NO.	REVISION/DESCRIPTION	BY	DATE
(1) 1	ADDENDUM 1	DE	12.04.12
0	FOR CONSTRUCTION	DE	12.04.05

PROJECT
ULTRAVIOLET SYSTEM AND PUMP UPGRADES
909 CONCORDIA AVE.

SHEET TITLE
RENOVATION LOW LEVEL

1 / M-2 MECHANICAL ROOM PLAN LOW LEVEL- RENOVATION

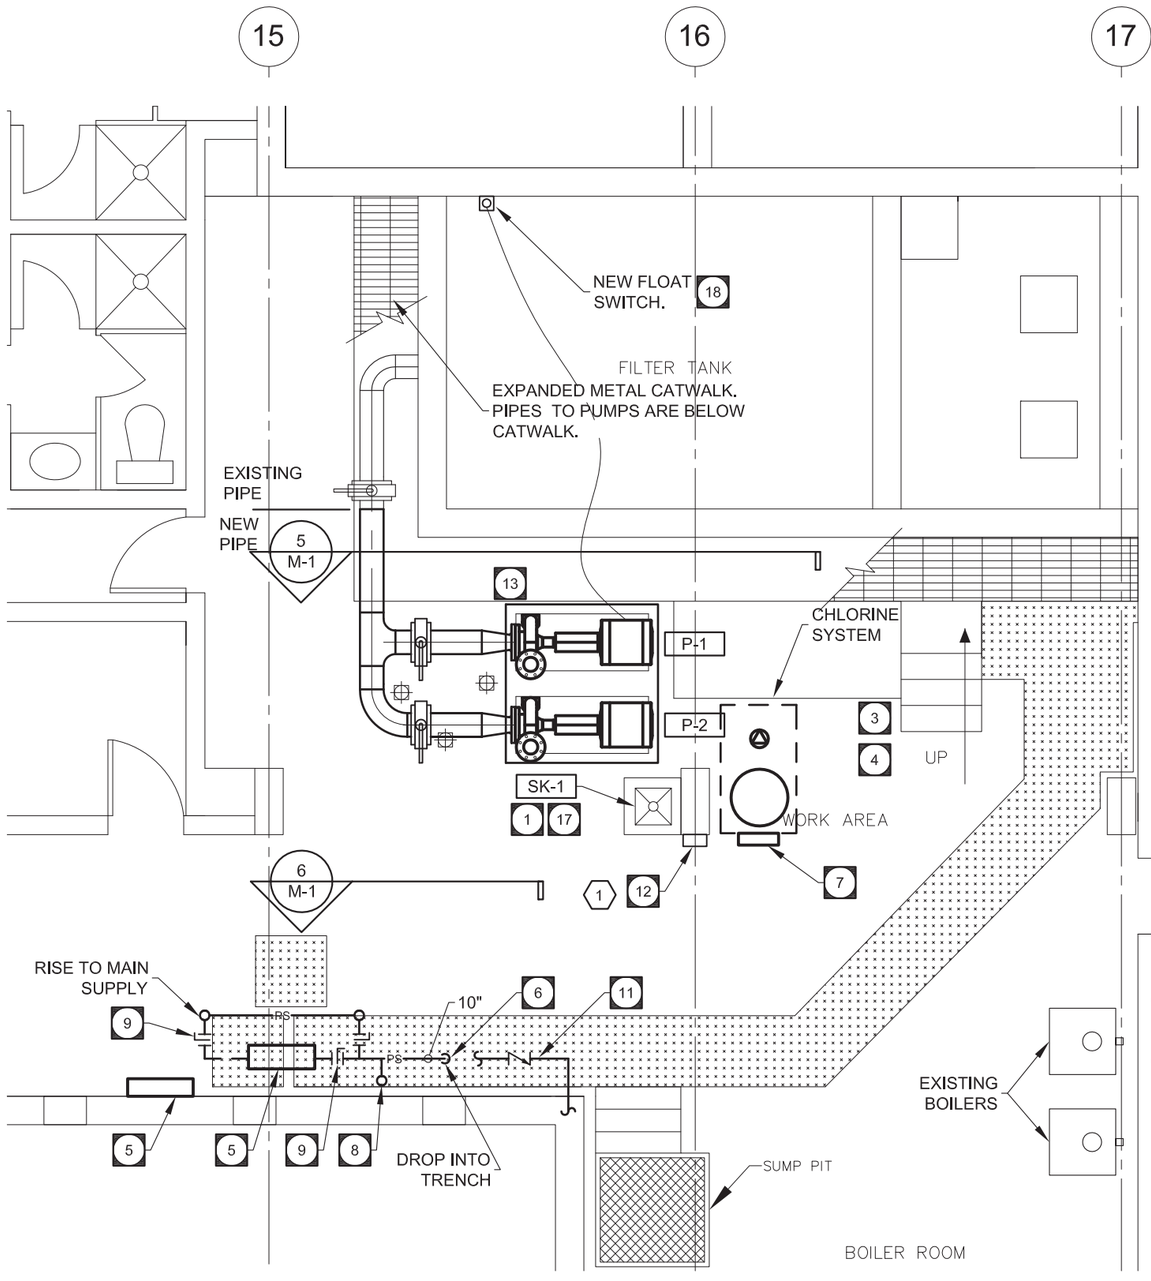
6. NEW FLOW METER.
7. (1) MOUNT CHLORINE SYSTEM CONTROLS ON A UNISTRUT STAND ON TOP OF EQUIPMENT PAD. BRACE TO COLUMN.
8. CONNECT CHLORINE RETURN PIPING AND CO2 DOWNSTREAM FROM UV TAKEOFF AND CONNECTION TO BOILER RETURN. UPSTREAM OF SYSTEM SHUT-OFF VALVE.

11. (1) NEW FULL-PORT CHECK VALVE. LOCATE ON 10" POOL SUPPLY PIPE IN CRAWLSPACE UNDER POOL. CONFIRM LOCATION ON SITE WITH OWNER.
12. (1) LOCATE FLOW METER DISPLAY ON FRONT OF COLUMN AS INDICATED. NEW DIGITAL FLOW METER DISPLAY. USE LOCAL POWER SUPPLY FOR METER.
